**MINUTES
BOARD OF BUILDING STANDARDS/
ARCHITECTURAL BOARD OF REVIEW/SIGN REVIEW
REVIEW MEETING
CITY OF LAKEWOOD
12650 DETROIT AVENUE
AUDITORIUM
JULY 13 2023
5:30 P.M.
RECORDED
<https://www.lakewoodoh.gov/videos-2/>**

July 2023

Docket No. 07-60-23 (1320 Bunts)
Home Addition

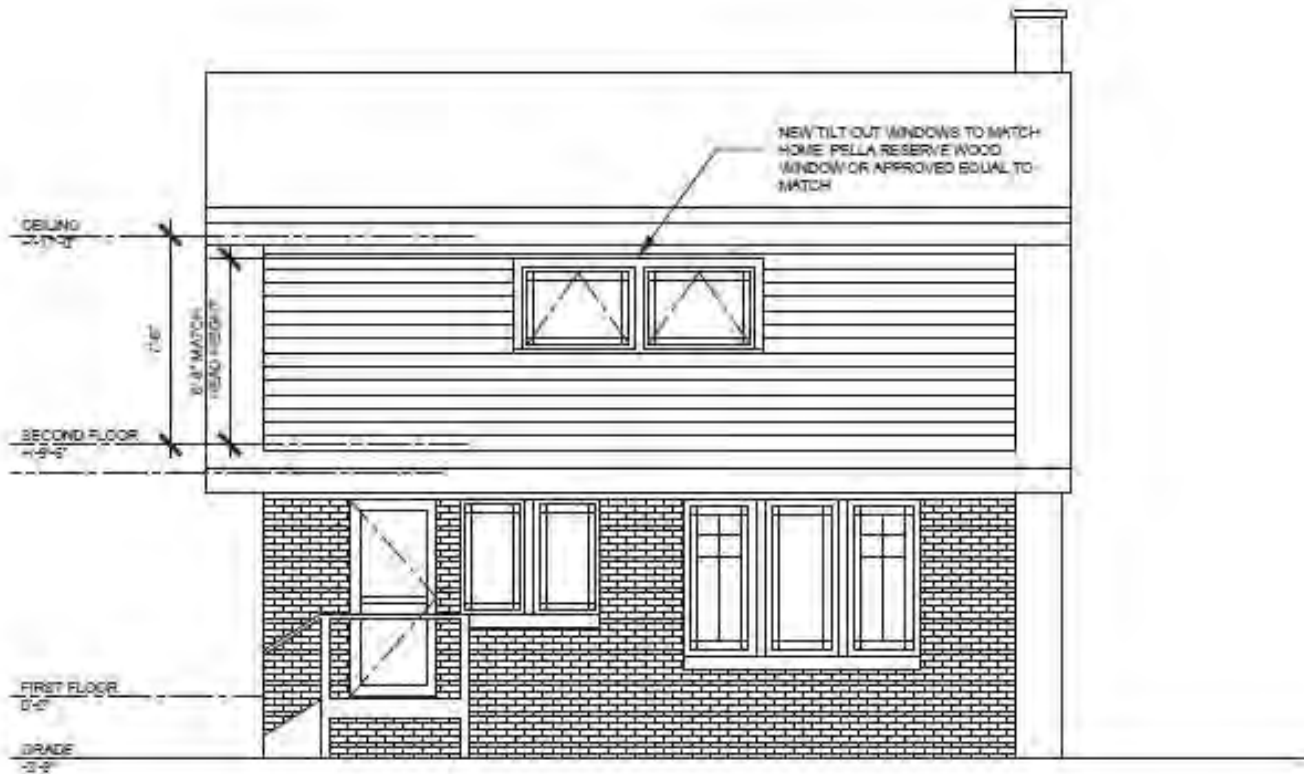
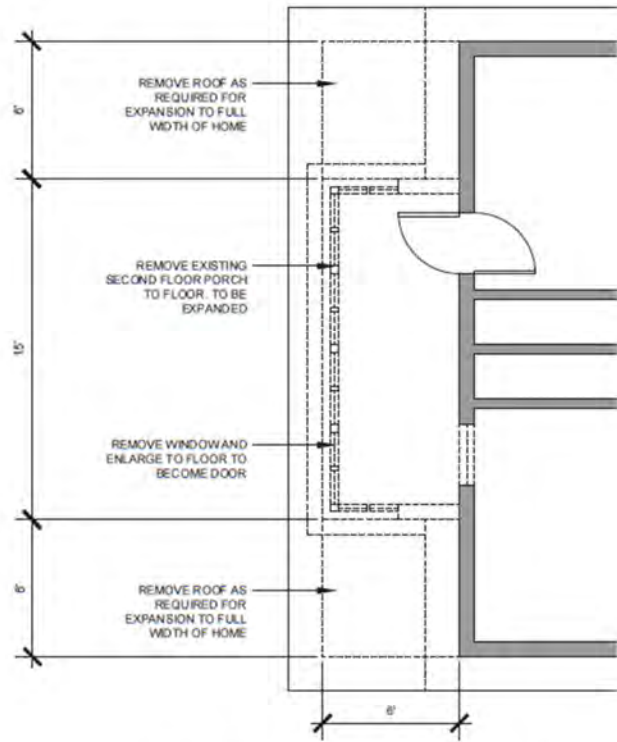
David J. Maniet AIA, Maniet Architects, applicant was present to explain the request (For this item, Mr. Maniet recused himself from the Board). Discussion began when it was disclosed the plan was amended to use asphalt shingles rather than a metal roof. Staff had no additional comments. Staff did not receive any communication prior to the meeting. Public comment was closed as no one addressed the item.

- **An updated package is submitted for administrative approval reflecting materials to match the existing, without the metal stanchion.**

Docket No. 07-61-23 (1434 Winchester)
 Front Porch Renovation

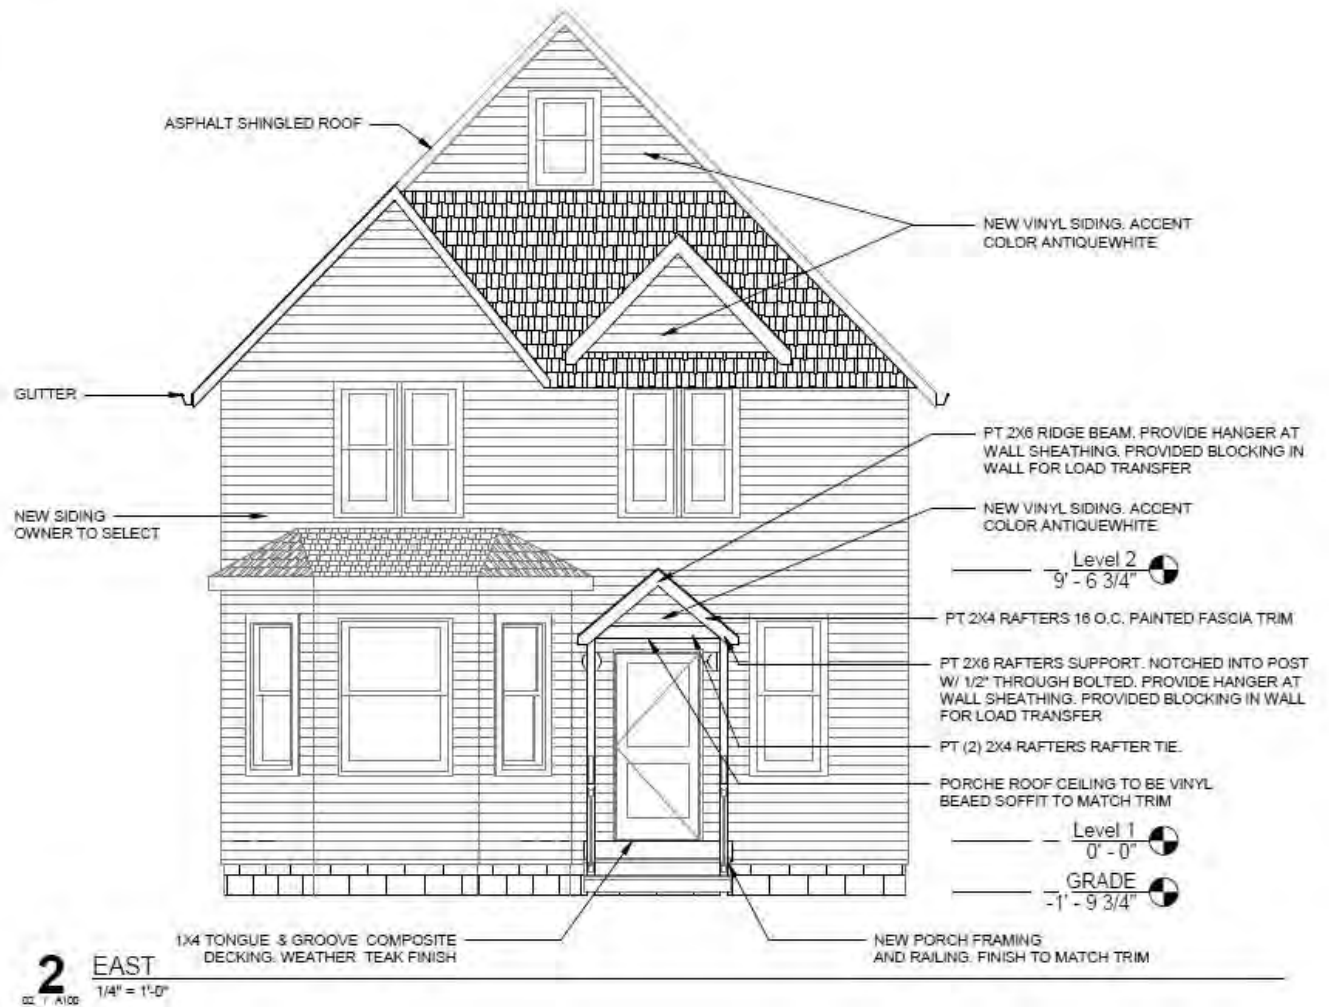
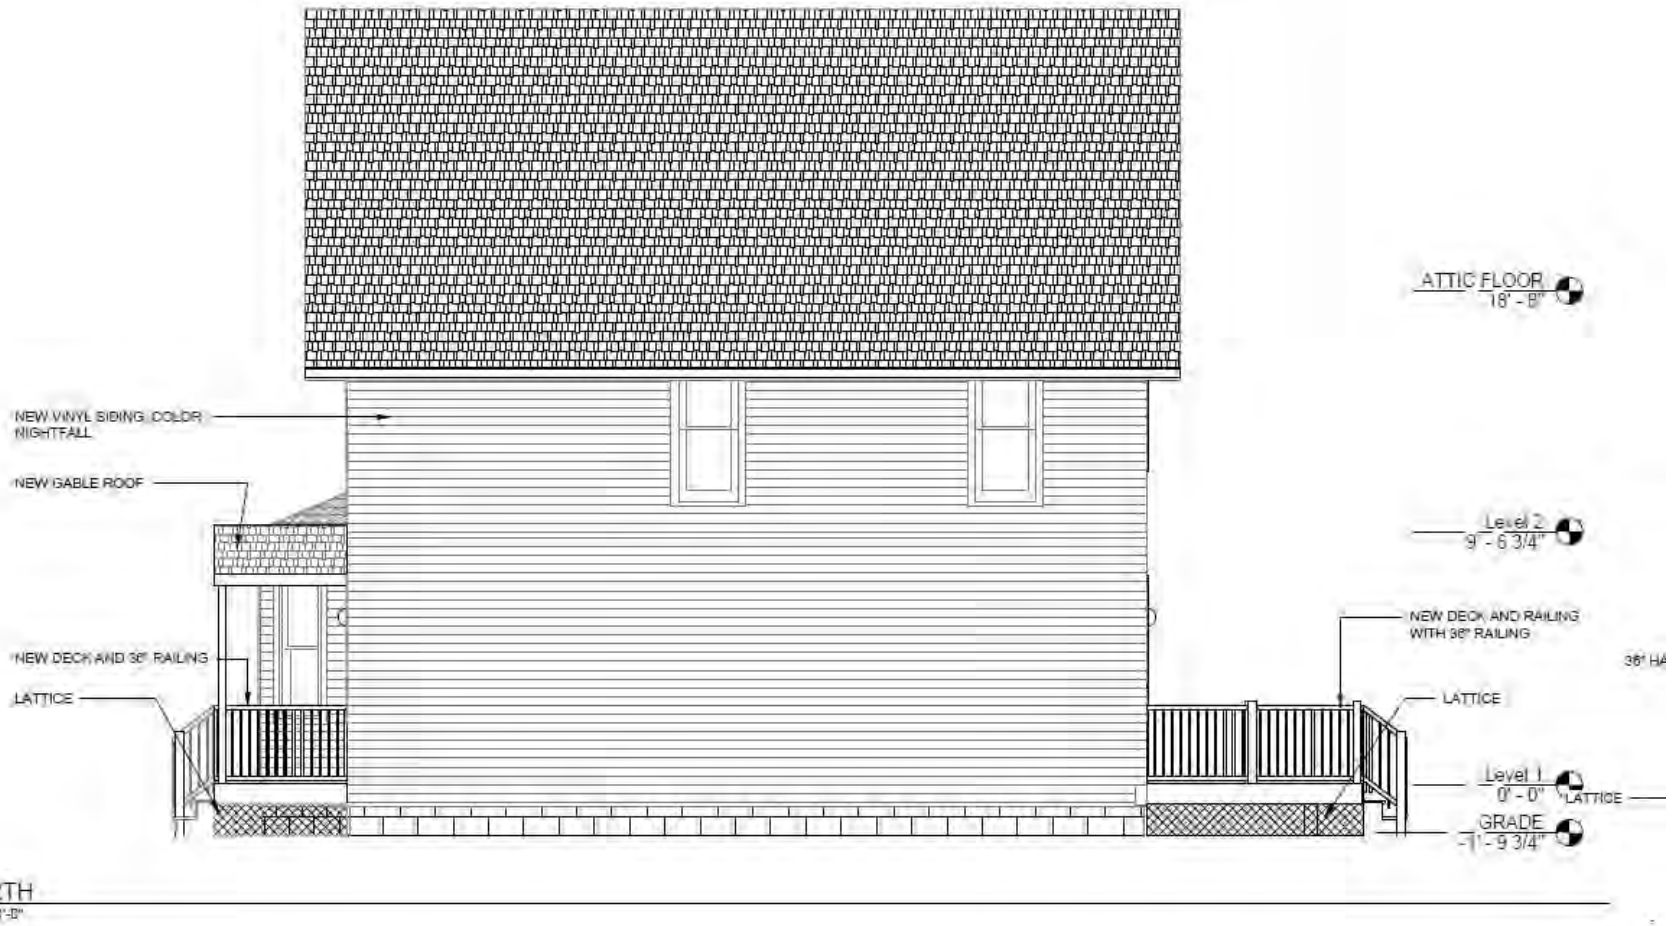
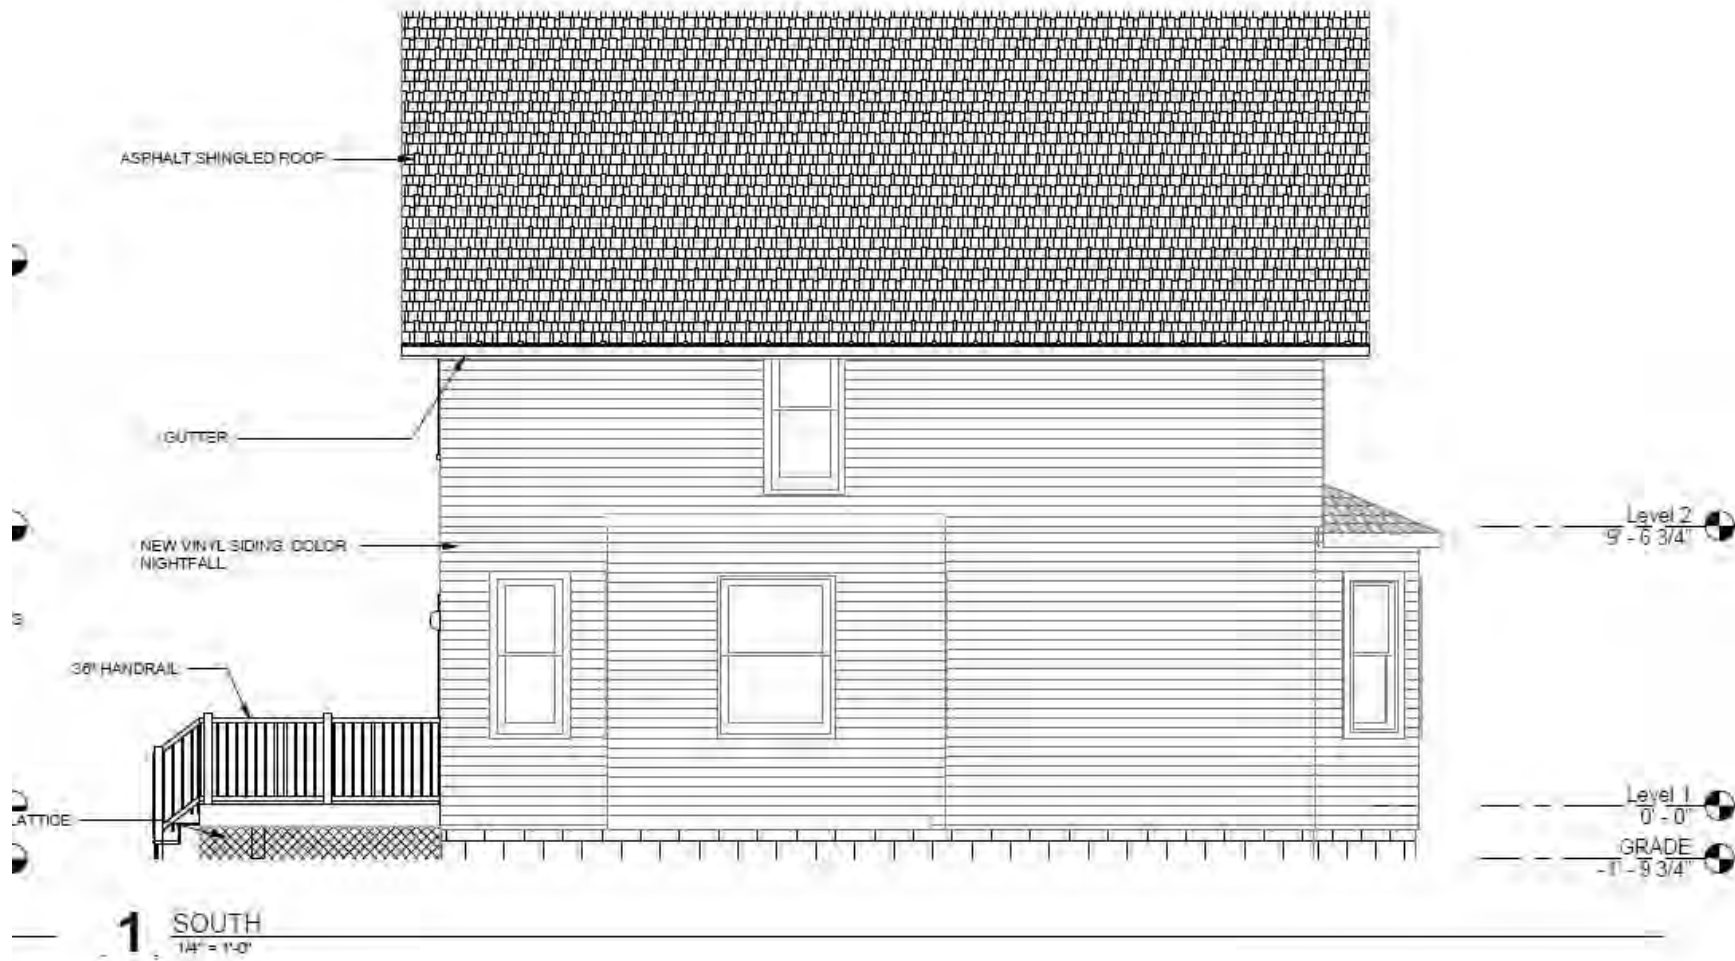
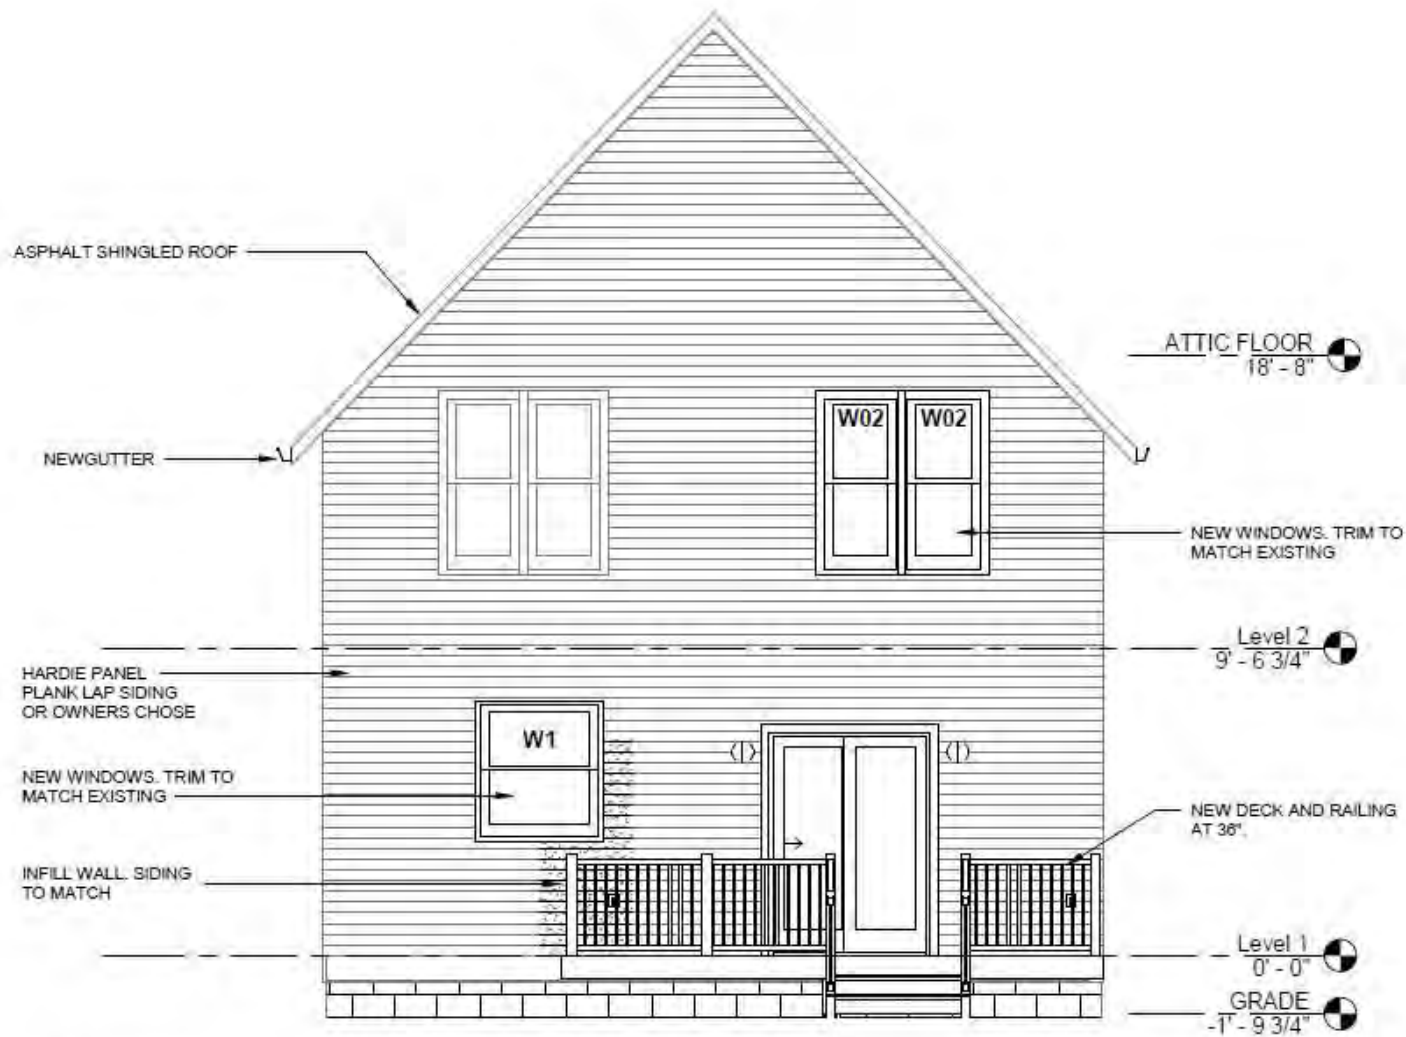
David Grootegoed AIA, Modamerican Design, applicant was present to explain the request. Discussion ensued about the columns, colors, railing, the city's design guidelines for porches, column caps/bases, lighting. Staff had no additional comments. Staff did not receive any communication prior to the meeting. Public comment was closed as no one addressed the item.

- **The columns will be finished and wrapped to better follow the design guidelines.**
- **The railing will not be included. If railing is included, a detail of the product is provided for administrative approval, following the design guidelines.**

PROPOSED ADDITION

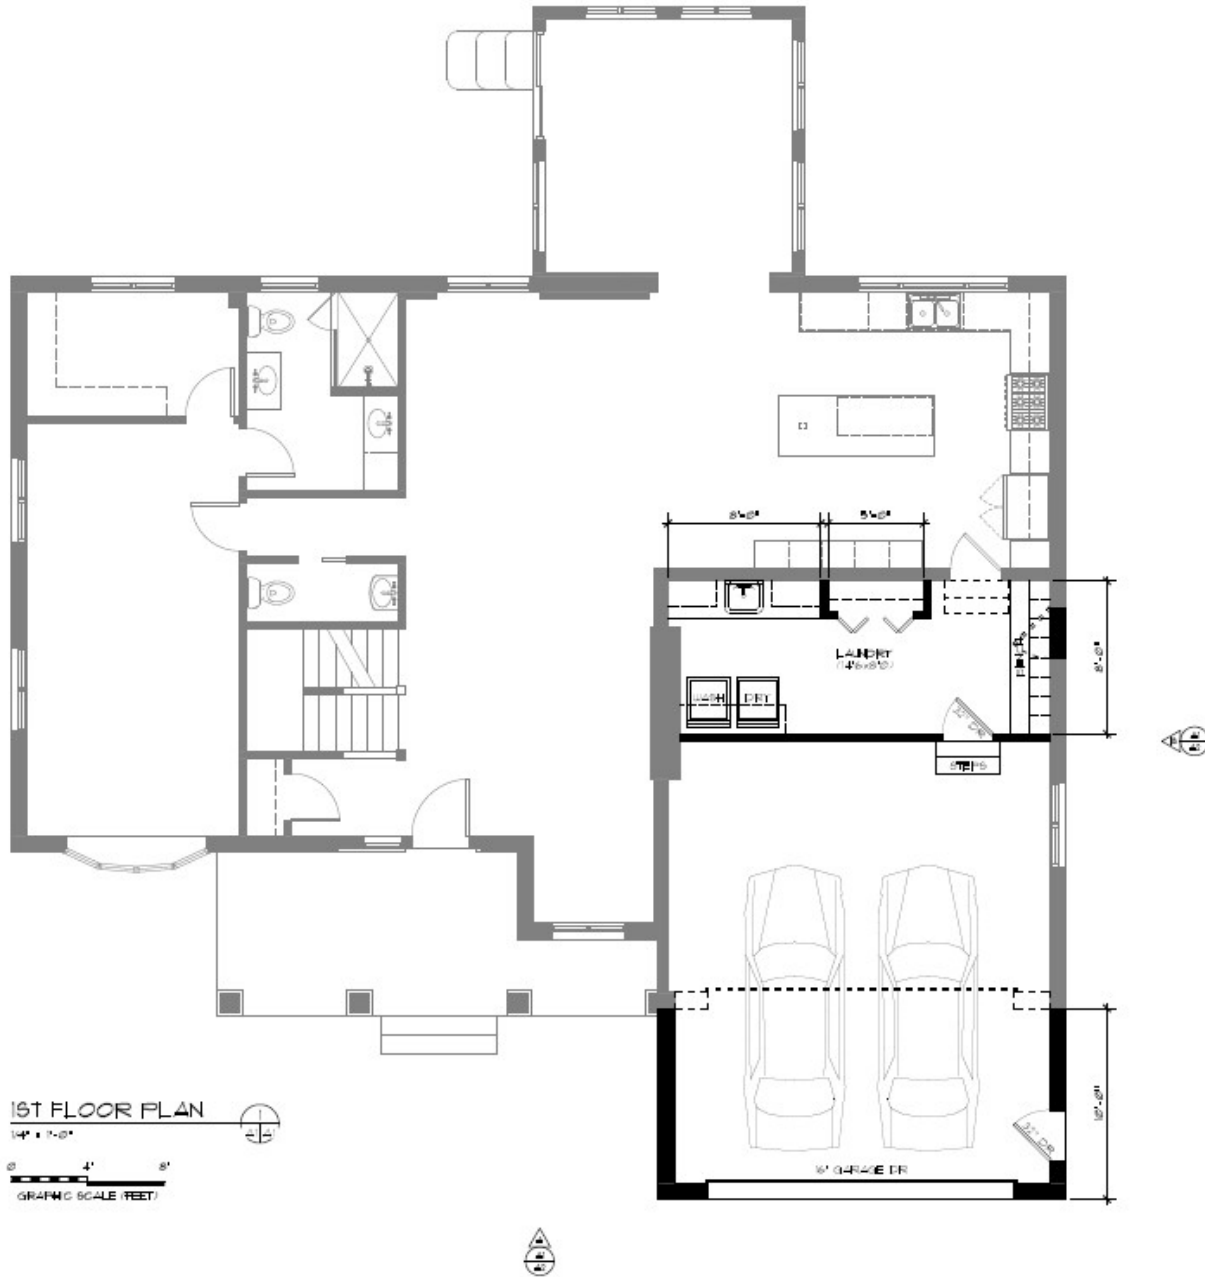
Paul Beegan, Beegan Architectural Design, applicant was present to explain the request. Brick, roofing, trim would match the existing structure. The members liked the proposal, asked about the vent above the garage door. Staff

- Proposed front setback is less than the requirement specified by the building line for this parcel: BZA hearing July 20.
- Request clarification on proposed finish materials - new brick is planned to match existing
- Clarification on light fixtures and garage door - using existing light fixtures on new garage face
